ADDENDUM #2

North Hancock Road Extension Phase IIIA and IIIB
Project No. 2014-11
Bid No. 14-0030

RESIDENTIAL DRIVEWAY

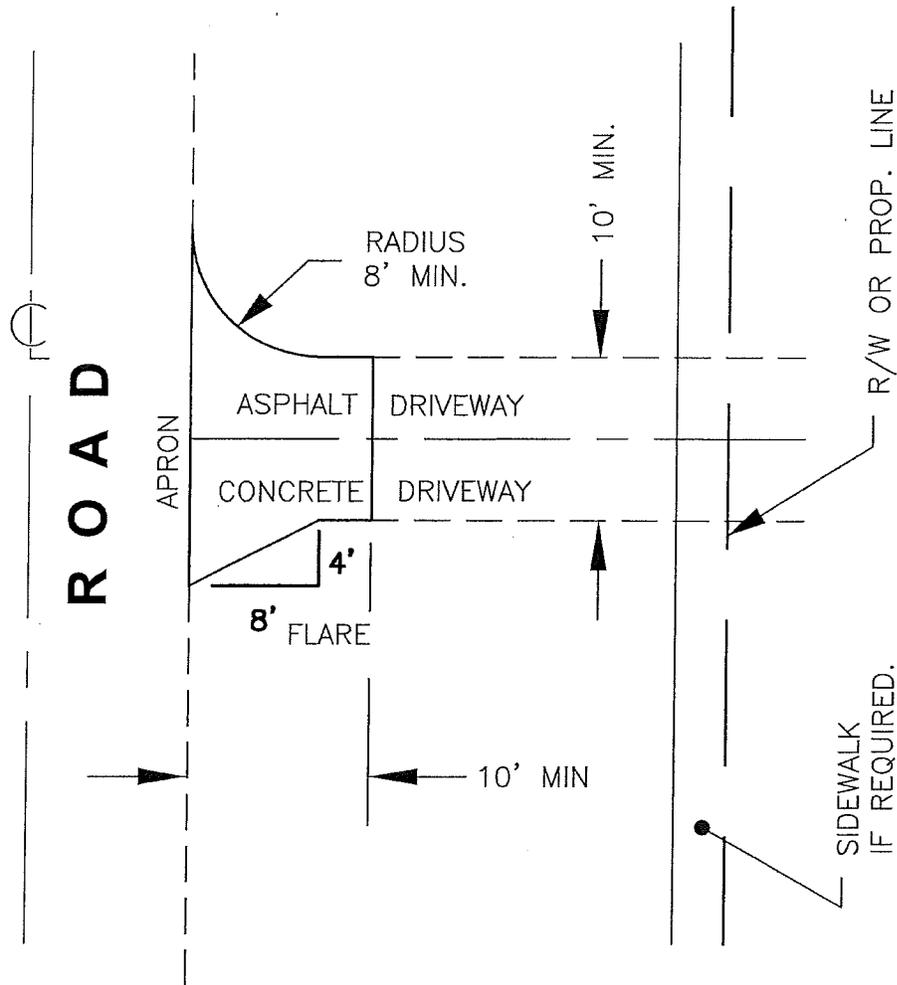
Q8. Please provide a detail for the construction of asphalt driveways.

A8. See attached "Standard A" driveway detail.

1. 1" ASPHALT W/6" COMPACTED LIMEROCK BASE.

OR

2. 6" 3,000 PSI CONCRETE REINFORCED W/ 10-10x6"x6" MESH AND 6" COMPACTED SUBGRADE

SHEET NO.
 11

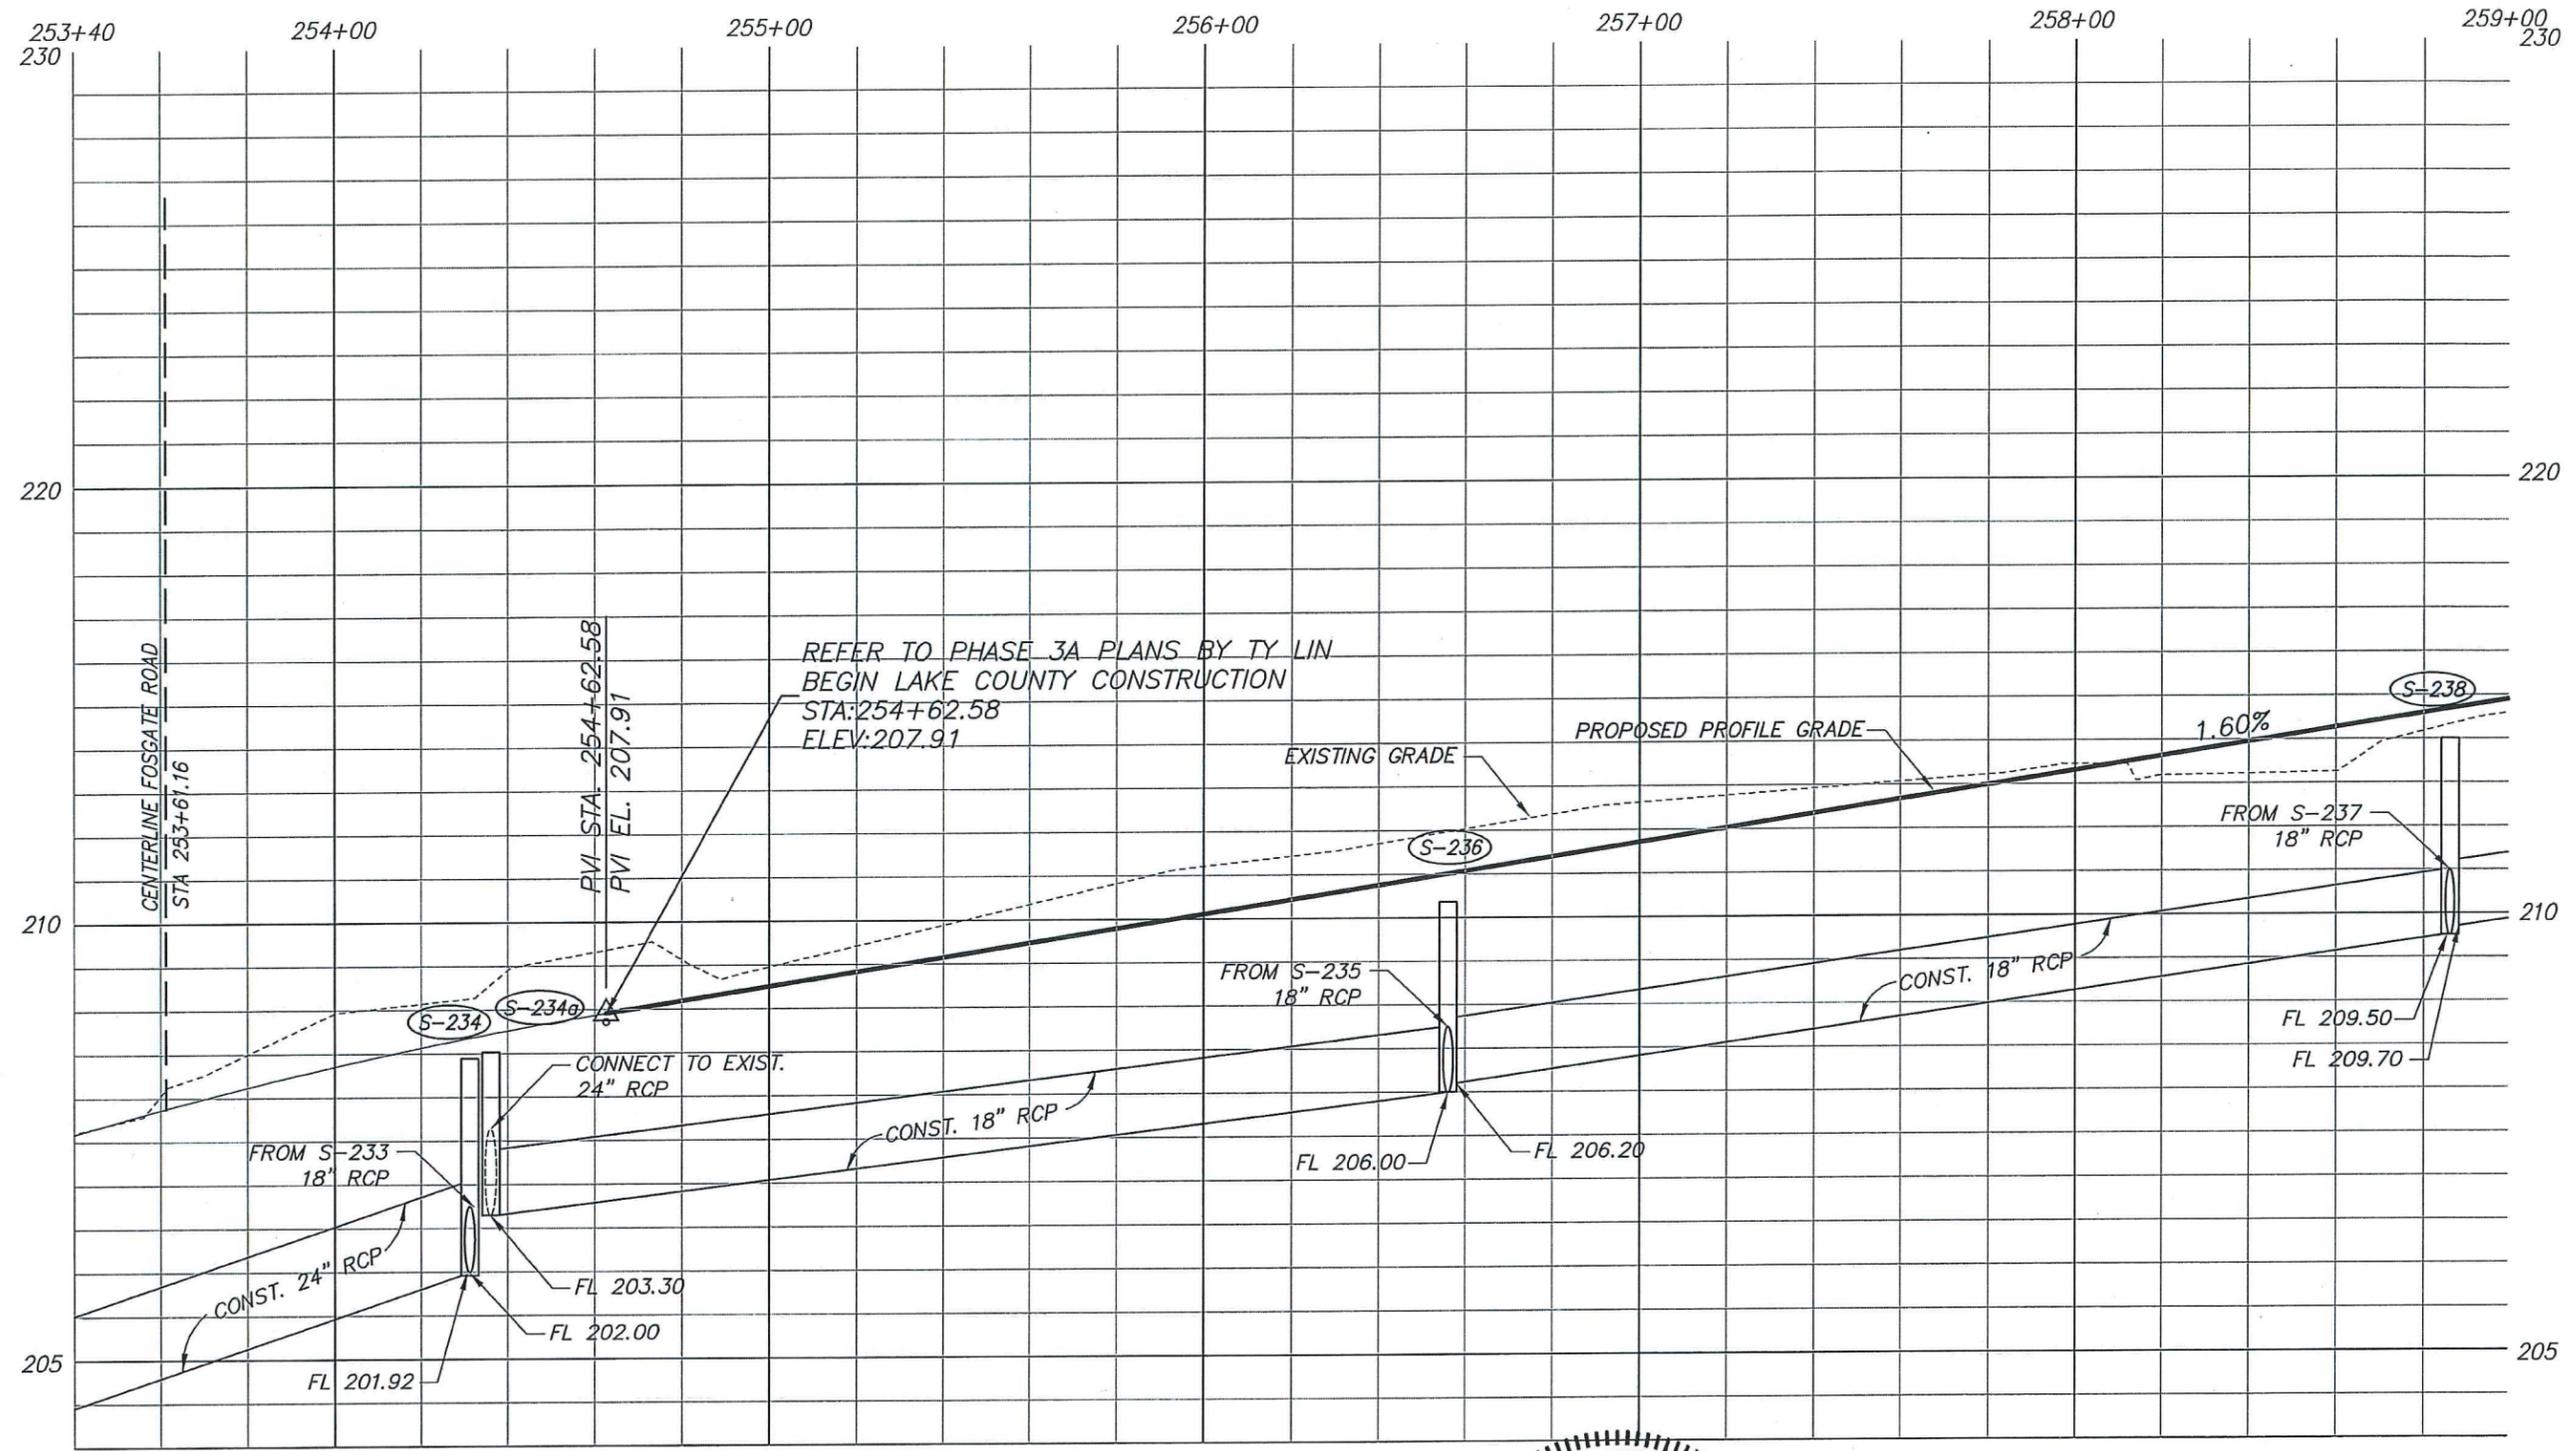
Included as part of this addendum are **revised** construction plan sheets 11-15 and 22-26 of the North Hancock Road Extension at Turnpike Interchange plans that addresses the connection to the future turnpike interchange project from STA 263+80 to STA 269+58.61. Bid to stripe this portion of the project consistent with current FDOT specifications and remainder of project. **Bidders shall utilize these revised sheets in developing their bid.**
